DESIGN <i>CP</i>	DRAWN BY <i>CP</i>	DART AEROSPACE LTD HAWKESBURY, ONTARIO, CANADA	
CHECKED <i>#</i>	APPROVED <i>#</i>	DRAWING NO. D3016	REV. A SHEET 1 OF 3
DATE 01.05.18		TITLE SEAT FRAME ASSEMBLY	SCALE NTS
A	01.05.18	NEW ISSUE

DRAWING NO. D3016	TITLE SEAT FRAME ASSEMBLY	REV. A	DART AEROSPACE LTD ENGINEERING ORDER	D.E.O. NO. D3016-A-1	SHEET NO. SHEET 1 OF 1	SCALE NTS
DRAWN 1	CHECKED UP	MFG. APPR. RE	APPROVED MP	DE APPR. MP		
DATE 10.01.29	DATE 10.01.29	DATE 10.01.29	DATE 10.01.29	DATE 10.01.29

TO REVISE D3016-11 SADDLE'S HOLE SIZES

D3016-11 SADDLE

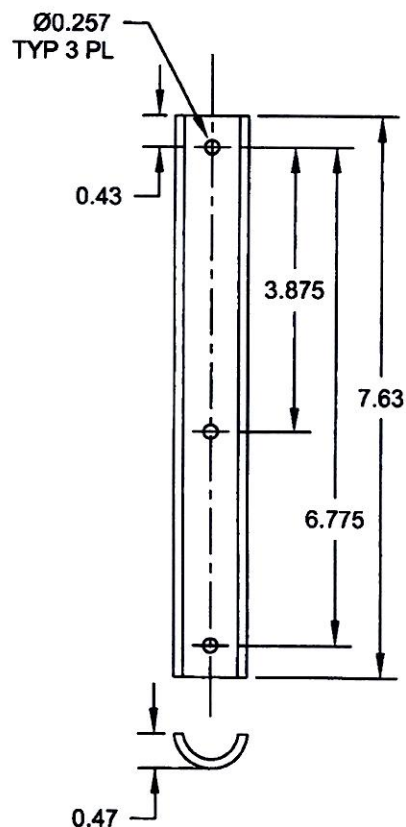
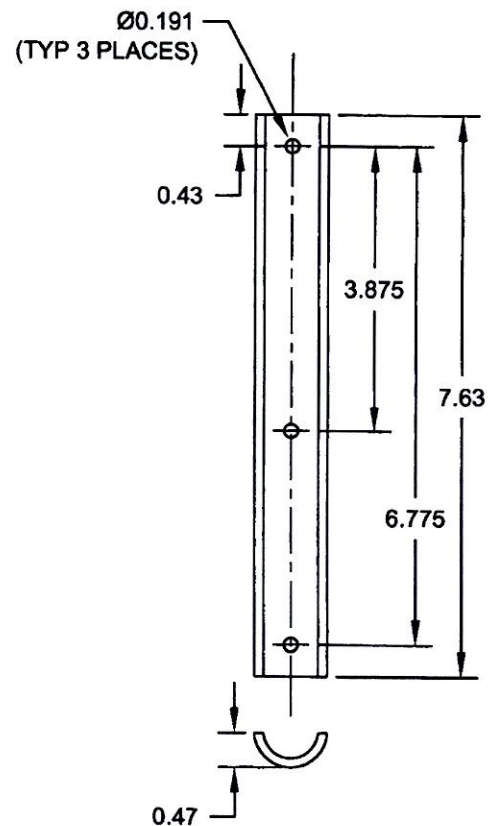
DETAIL D3016-11 SADDLE (SHEET 3): Ø0.257 TYP 3 PL WAS Ø0.191 (TYP 3 PLACES) AS SHOWN:
